<b>AMENDMENT OF SOLICITATION/MODIFICATION OF CONTRACT</b>				1. CONTRACT ID CODE	PAGE 1 OF 6 PAGES
2. AMENDMENT/MODIFICATION NO. AMENDMENT NO. 0010		3. EFFECTIVE DATE 06/03/14	4. REQUISITION/PURCHASE REQ. NO.	5. PROJECT NO. (If applicable) 12-0088	
6. ISSUED BY CODE		mks	7. ADMINISTERED BY (If other than Item 6) CODE		See Item 6
8. NAME AND ADDRESS OF CONTRACTOR (No., street, county, State and ZIP Code)  Officer in Charge of Construction MCI-East 1005 Michael Road Camp Lejeune, NC 28547-2521			(X)	9A. AMENDMENT OF SOLICITATION NO. N40085-12-R-0088	
			X	9B. DATED (SEE ITEM 11) 03/25/14	
				10A. MODIFICATION OF CONTRACT/ORDER NO.	
				10B. DATED (SEE ITEM 11)	
CODE	FACILITY CODE

12-0088 Repair Electronic Maintenance Shop, Building HP104

Amendment 0010

### CONTINUATION SHEET

Sketch S2 - Record Drawing of Roof Framing Plan showing unit locations and additional structural members

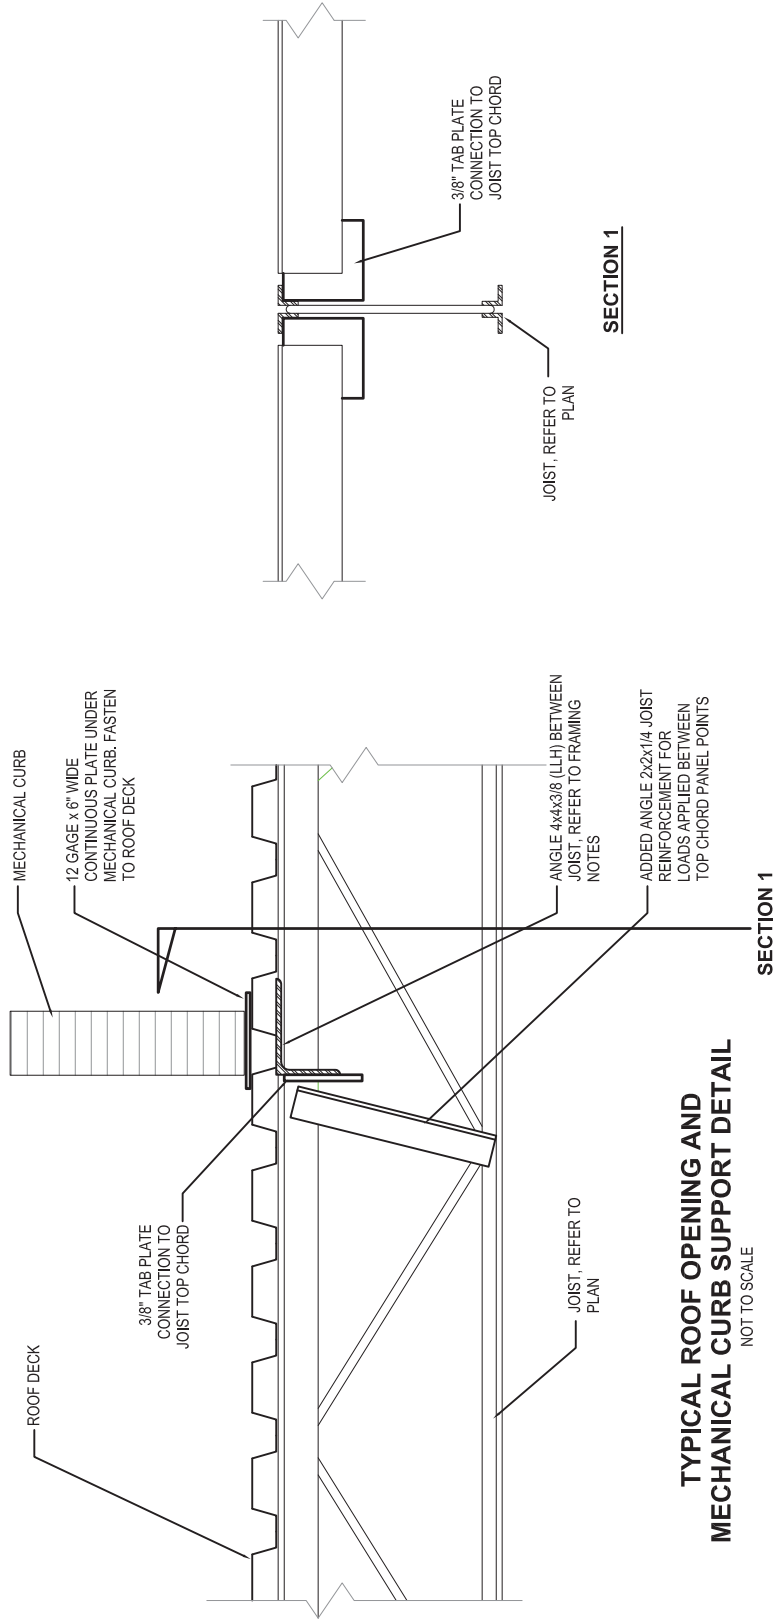
1. Question: There are 7 new RTU's that will require new curbs. There are 5 H&V units that are going on the roof that will require new curbs (the existing H&V units are under the roof). Will any additional structural support be required for these new curbs?

1. Response: Concerning structural modifications required at new roof penetrations for (7) RTUs (5) HVUs (6) new flue penetrations, please see the attached sketches showing Structural changes to support these units:
